Fw: EN010127 Field 18, Mallard Pass Solar Farm

Subject: RE: EN010127 Field 18,

Extract REP1-034

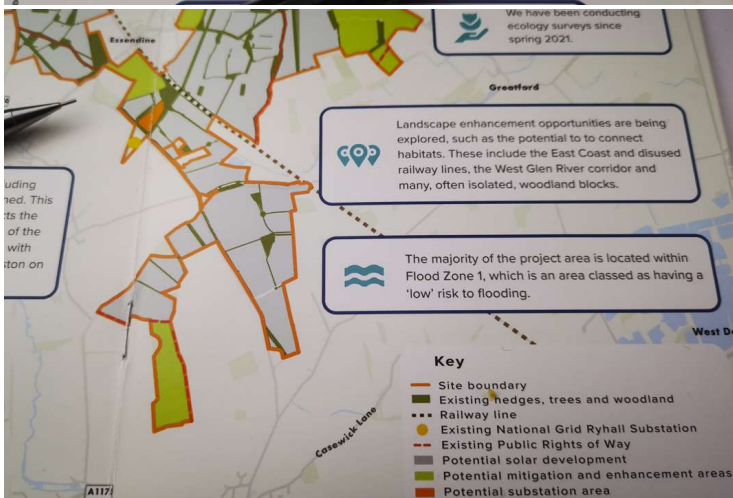
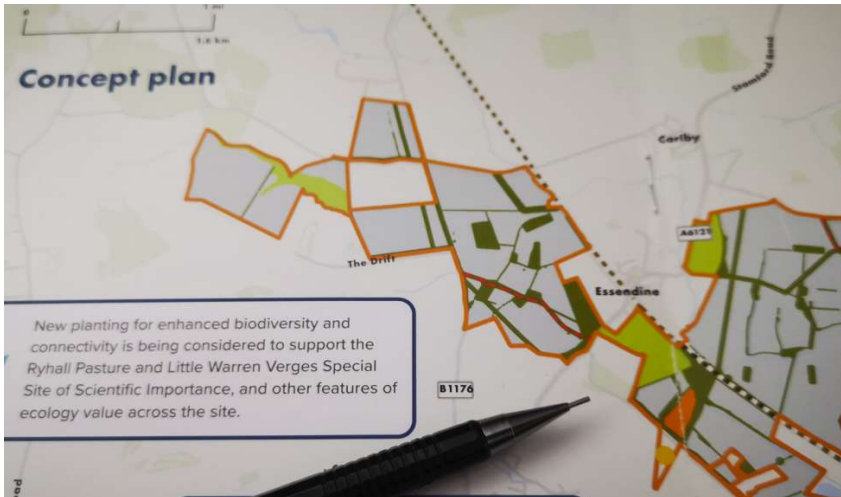
The drone markers were used for topography purposes based on the response below, if that is the case why does no one from MPSF recognise that the land behind Glen Crescent and west of the ECML along the A6121 slopes away from the village making field 18 which rises up highly visible, if the people carrying out the mitigated planting made note of the topography they will see its effect will be minimal as its be planted along the lowest boundary of the field, as photomontage APP-172 shows as does the photograph from the lounge and kitchen windows, The PV arrays will be visible

Photomontage APP-172 is also wrong and mis represents the orientation of the solar panels showing them to be facing west, residents west of the ECML if PV arrays are put in field 18 we will see the mounting structures to which there has been no discussion of final finish and based on current assumptions would be galvanised steel representing a mass of scaffolding. Where is the representation for the seasonal variation but also the and requested wire line drawing to show the true visual impact of what residents will see. The DCO should be reflective of what we the residents will see and endure not the rose tinted spectacle view that the applicant wants to purvey the view of a driver travelling along the A6121, they are using a high point to try and minimise the visual impact. **Where is the stripped out vegetative wire line drawing showing the true impact? Where is the seasonal representation?**

Photomontage E [APP-172] provides a visualisation of the proposed substation looking from Stamford Road (A6121). This photomontage illustrates the screening effect of a hedgerow with individual hedgeline trees, which provides an element of screening of the PV Arrays. It should be noted that whilst Photomontage E is an illustrative photomontage, the Green Infrastructure Strategy [REP7-021] proposes for a tree belt to be located along the alignment of the hedgerow. An illustrative photomontage depicting the proposed tree belt is shown on the Onsite Substation wireline [Appendix D, REP4-002]. The tree belt strengthens the screening of the PV Arrays located in fields 26 and 18 and the substation in Field 19. The proposed tree belt is seen in the context of the existing wooded disused railway line, helping assimilate it into its immediate landscape context.
